Access Compliance Report

Public Rights-of-Way

(Curb Ramps)

Intersection ID: 10019902	Main Street: ARCO_CORPORATE_DR	Cross Street: N/A	Location: SE
ADA ID: 7E09ACE38E18	Ramp Type: PerpDiag	Initial Pass/Fail: Fail	Overall Compliance: No
Severity Score: 25			
Codes/Mitigation Info/Possible Solution		Field Measurements/Component Compliance

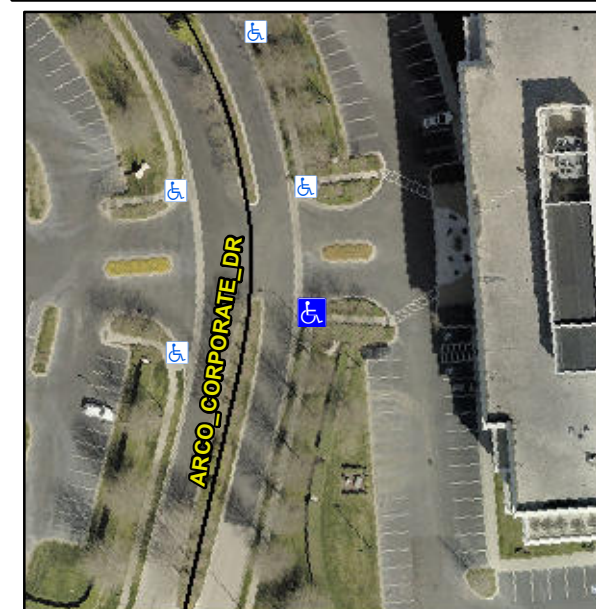
Not Found, R304.2.2

Compliance	Description	Data	Compliance	Description	Data
N/A	Ramp Length (in)	28.0	No	Ramp Slope (%)	12.5
Yes	Ramp Width (in)	48.0	Yes	Ramp XSlope (%)	0.4
N/A	Flare Type LT	N/A	N/A	Flare Type RT	N/A
N/A	Flare Slope LT (%)	N/A	N/A	Flare Slope RT (%)	N/A
N/A	Flare Traversable LT?	N/A	N/A	Flare Traversable RT?	N/A
N/A	Landing Length (in)	N/A	N/A	DWS Provided?	N/A
N/A	Landing Width (in)	N/A	N/A	DWS Contrast?	N/A
N/A	Landing Slope (%)	N/A	N/A	DWS Length (in)	N/A
N/A	Landing X Slope (%)	N/A	N/A	DWS Full Width?	N/A
N/A	Landing Curb? (Y/N)	N/A	N/A	DWS Offset (in)	N/A
N/A	Shared Landing?	N/A			
N/A	Gutter Ponding?	N/A	N/A	Gutter Slope (%)	N/A
N/A	Gutter Lip Ht (in)	N/A	N/A	Gutter X Slope (%)	N/A
N/A	Painted X Walk1?	No	N/A	Painted X Walk2?	No
	X Walk 1 Direction	To N		X Walk 2 Direction	To W
N/A	X Walk 1 Width (in)	N/A	N/A	X Walk 2 Width (in)	N/A
	X Walk 1 Slope (%)	4.4		X Walk 2 Slope (%)	3.1
	X Walk 1 X Slope (%)	6.1		X Walk 2 X Slope (%)	3.4

Remove & Replace Curb Ramp With Two New Directional Ramps or Equivalent.
